Bicycle Master Plan Public Hearing Draft Work Session #1

Completed: 02/08/2018

DESCRIPTION

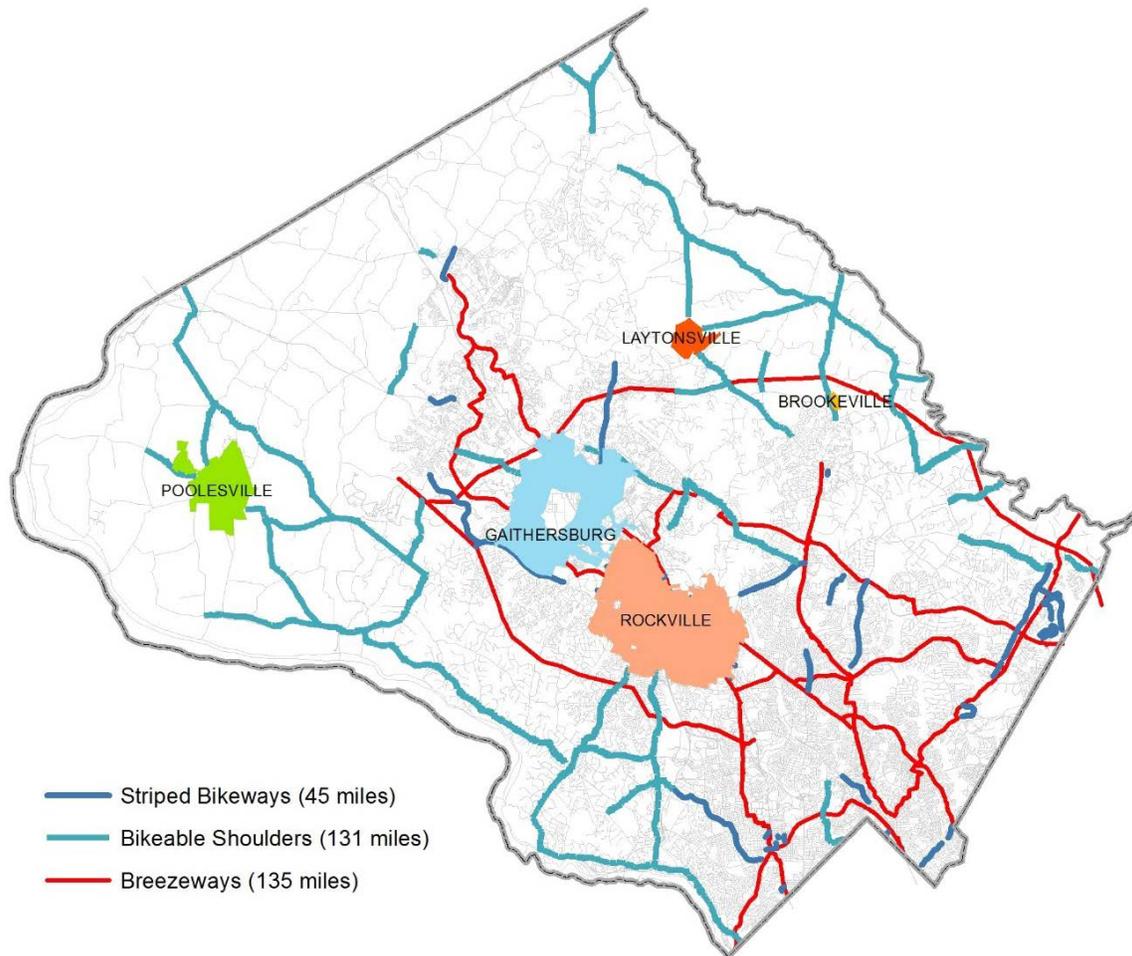
We believe that this plan provides a robust network for “moderate-stress” bicyclists, including about 300 miles of bikeways that are targeted to them, as shown in the map below. This includes:

- Bike Lanes (dark blue): 45 miles of bike lanes, including 30 miles of new bike lanes.
- Bikeable Shoulders (light blue): over 130 miles, which will benefit many recreational bicyclists.
- Breezeway Network (red): 135 miles

We are concerned that giving greater priority to the construction of bike lanes and bikeable shoulders will make it more difficult to implement a high-quality, low-stress bikeway. **If the Planning Board wants to address Mr. Cochrane's concerns without deprioritizing low-stress bikeways, they could consider including this statement on the bottom of page 38 (changes to Mr. Cochrane's proposed language are shown with underlining and strikethroughs):**
